Norfolk Boreas Offshore Wind Farm

Statement of Common Ground

Natural England

Applicant: Norfolk Boreas Limited
Document Reference: ExA.SoCG-17.D16.V5
Deadline: 16
Date: September 2020
Revision: Version 5
Author: Royal HaskoningDHV

Figure 1 *Sabellaria spinulosa* reef mapping by the Applicant and Natural England

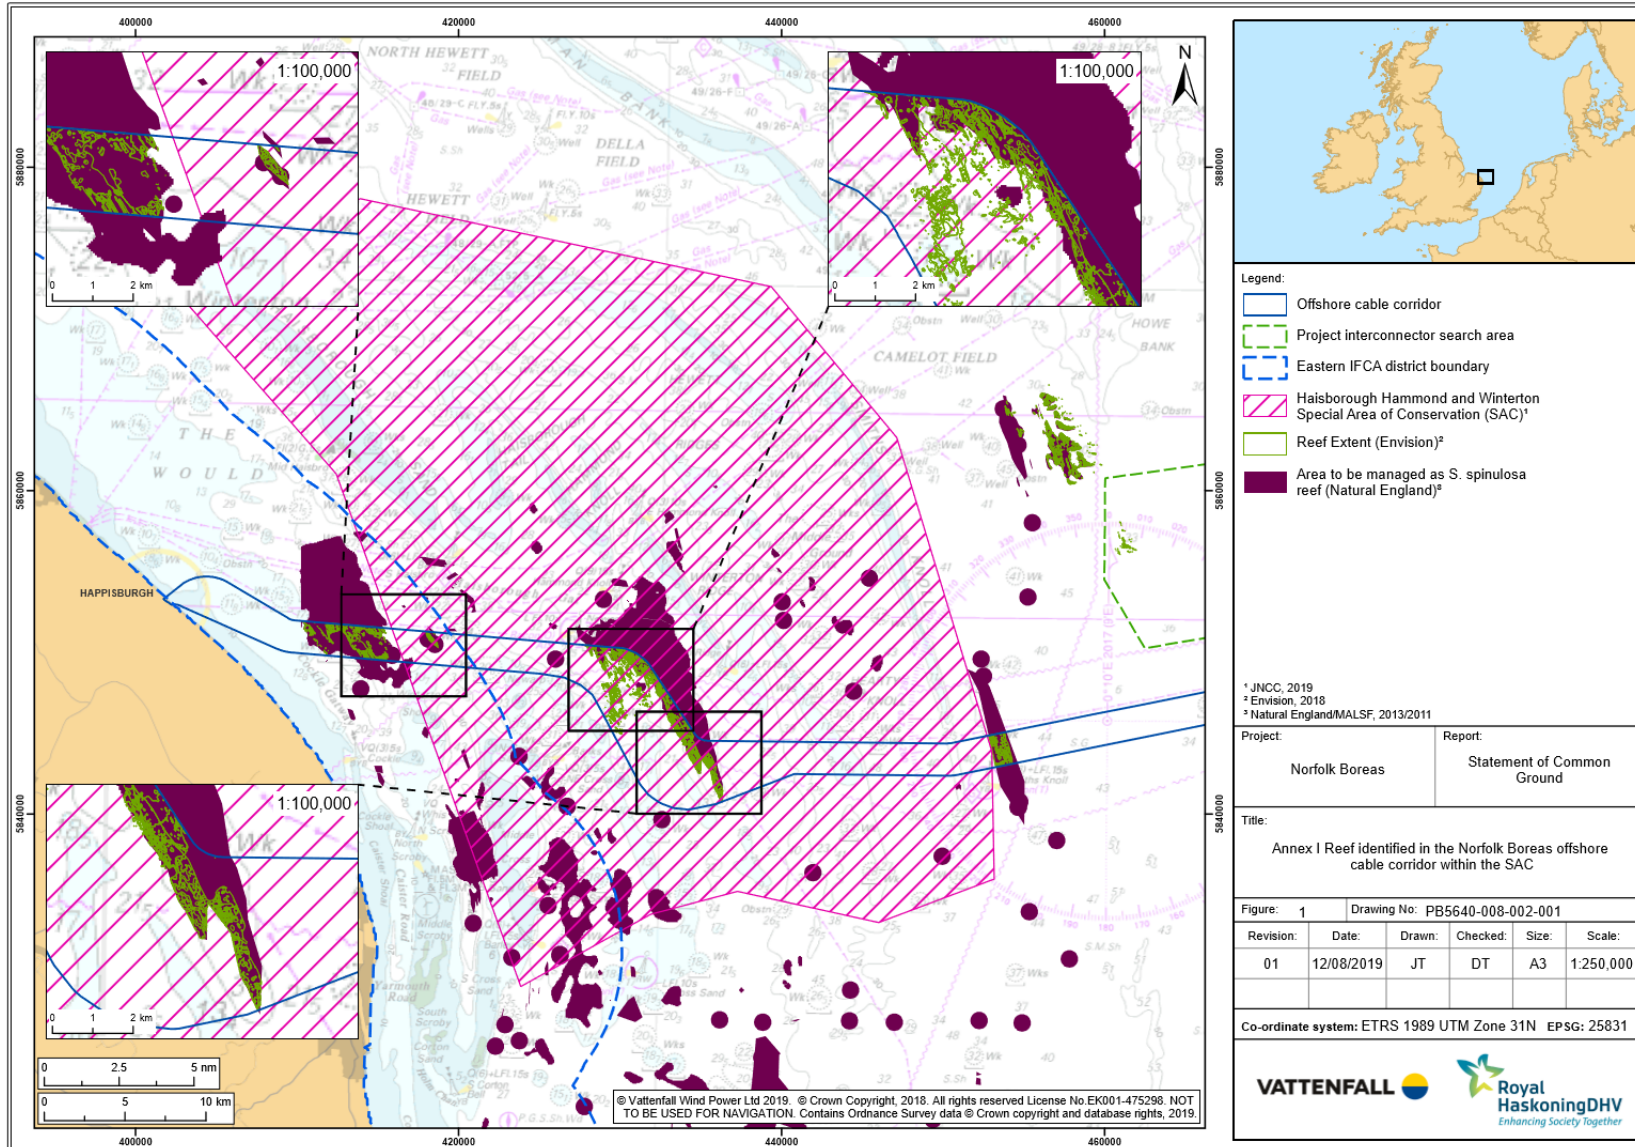
Topic	Norfolk Boreas Limited position	Natural England position	Final position
		(D10) Natural England advise that all reef, including patchy reef, should be avoided by micro-siting and Natural England are not confident that this will be possible.	
	The mapping of potential <i>S. spinulosa</i> reef by Envision on behalf of Norfolk Boreas (and Norfolk Vanguard Limited) identifies potential reef areas which are largely consistent with areas Natural England has identified (as shown on Figure 2.1 below).	Agreed	Agreed
Assessment methodology	Appropriate legislation, planning policy and guidance relevant to Benthic and Intertidal Ecology has been used.	<p>Agreed, but with the caveat that there is disagreement between the parties on the application of the Habitats Directive. Please see Natural England issues log which will be submitted at Deadline 2.</p> <p>Please also see Position Statement Regarding the Proposed Site Integrity Plan for the Haisborough Hammond and Winterton Special Area of Conservation [REP4-041]</p>	(D10) Agreed for EIA (but not for HRA – see below).

Topic	Norfolk Boreas Limited position	Natural England position	Final position
		(D16) Natural England is cognisant of the decision made by the SoS for the Norfolk Vanguard project, however this does not change the advice provided by Natural England for the Norfolk Boreas project.	this cannot be conclusively demonstrated at this time.
	<p>Based on available data, micrositing around <i>S. spinulosa</i> reef is likely to be possible. However, it is acknowledged that <i>S. spinulosa</i> reef extent may change prior to construction of Norfolk Boreas and therefore pre-construction surveys are required to determine the extent of <i>S. spinulosa</i> reef at that time. A cable specification, installation and monitoring plan, must be agreed with the MMO in consultation with Natural England as discussed under 'Mitigation and Management' below. This will provide the mechanism to agree cable routing/micrositing.</p> <p>(D10) As described in the Applicant's Haisborough Hammond and Winterton Special Area of Conservation Position Paper [REP5-057], the Applicant maintains that the current survey data shows that micrositing will be possible. Also as set out in the position paper (paragraph 16c) the Applicant does not consider that the proposed fishing restrictions are likely to result in a large change in fishing pressure as the current levels of fishing in these areas are extremely low. Therefore the Applicant maintains that the extent of <i>S. spinulosa</i> reef within the section of the HHW SAC which overlaps with the offshore cable corridor is unlikely to change significantly prior to Norfolk Boreas construction. Therefore, micrositing at the time of construction is highly likely to be possible.</p>	<p>Not agreed, Natural England has outlined concerns within the Relevant Representation [RR-099] regarding the Applicant's ability to microsite around Sabellaria reef.</p> <p>(D10) Natural England have submitted the following in support of their position:</p> <p>At D4: Position Statement Regarding the Proposed Site Integrity Plan for the Haisborough Hammond and Winterton Special Area of Conservation [REP4-041]; and Natural England's Written Summary of Oral Representations made at Issue Specific Hearing 4 on offshore effects including the Draft Development Consent Order [REP4-043].</p> <p>At D5: Natural England's advice on Applicant's clarification note on optimising cable routing through the HHW SAC [REP5-081]</p> <p>At D7: Natural England's comments on the Applicant's Haisborough Hammond and Winterton SAC Position Paper of February 2020 [REP7-051].</p>	(D10) Final position is that the Applicant and Natural England do not agree whether micrositing around <i>S. spinulosa</i> reef will be possible with certainty. The Applicant maintains that available data shows that micrositing would be possible at the current time and due to the fact that the current level of fishing pressure within the SAC is low it is unlikely that restrictions on fishing activity will significantly increase the extent of Annex I <i>S. spinulosa</i> reef within the SAC and therefore micrositing will still be possible at the time of construction. Natural England maintain that there remains a risk that the extent of <i>S. spinulosa</i> reef at the time of construction may be such that micrositing is not possible.
